Delegated or Committee Planning Application Report and Report of Handling as required by Schedule 2 of the Town and Country Planning (Development Management Procedure) (Scotland) Regulations 2013 relative to applications for Planning Permission or Planning Permission in Principle

Reference No: 21/02709/PP

Proposal: Variation of condition numbers 3, 4, 5 and 6 and removal of conditions 7 and 8 relative to planning permission 20/01150/PP (Erection of dwellinghouse). Access arrangements

SUPPLEMENTARY REPORT NO. 1

This supplementary report has been provided with regards to proposed drawing reference 19/20/10 as an updated drawing (ref: 19/20/10 REV A) below, has been supplied by the applicant. The roads officer has provided further comment on this drawing and has noted;

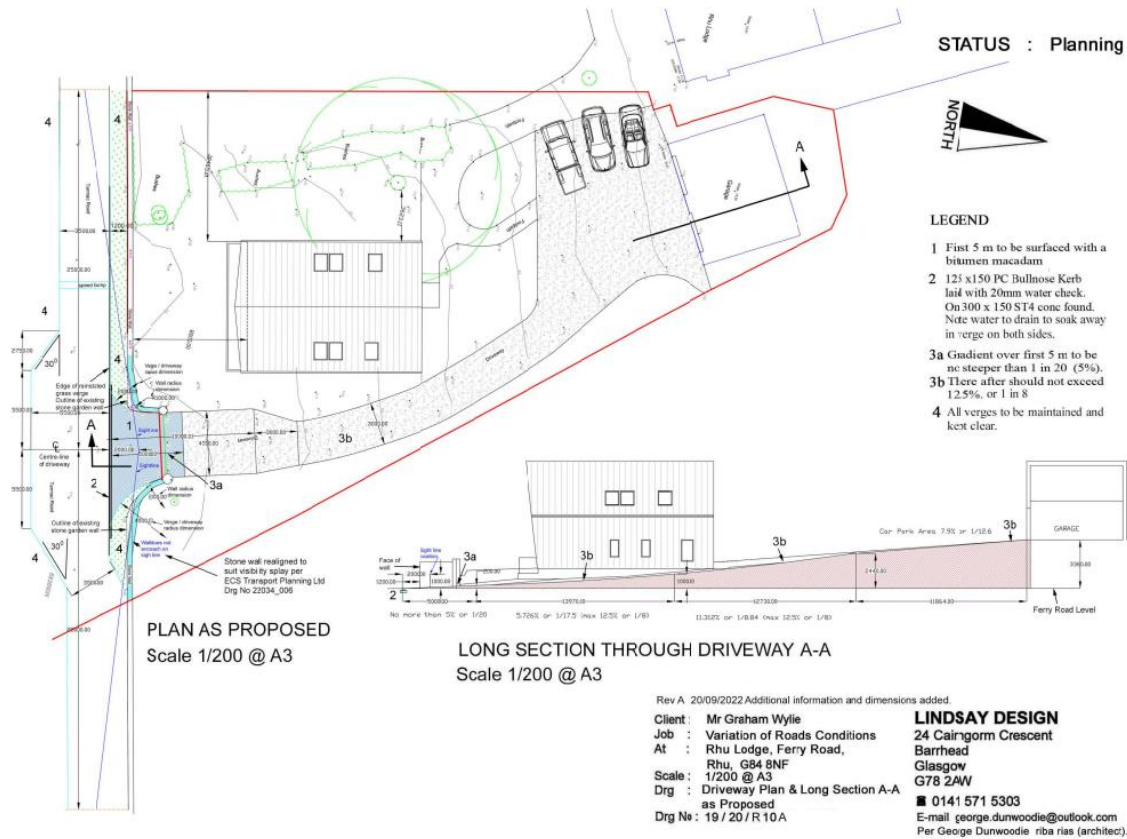
Whilst the details as shown within this drawing noting the 4.5m wide driveway for the first 10m, the radius and the kerb with water check are correct, it is noted that they have been shown in the incorrect location as these should be measured back from the boundary wall and not from a point beyond the boundary wall therefore, the details contained within this drawing are not acceptable.

In terms of the proposed passing place at the driveway access and proposals to install a grass verge, it is noted that the visibility splays as detailed within revised drawing 9/20/10 REV A show the splays taken from a point beyond the boundary / edge of existing carriageway. There is no existing verge, if the applicant wishes to realign the road to install a verge then we would need specific details on this, in terms of road construction. Furthermore, this would no longer solely be assessed as a passing place but as a road realignment and therefore, the details within this drawing are not acceptable as the angle is too acute hence the requirement for a condition.
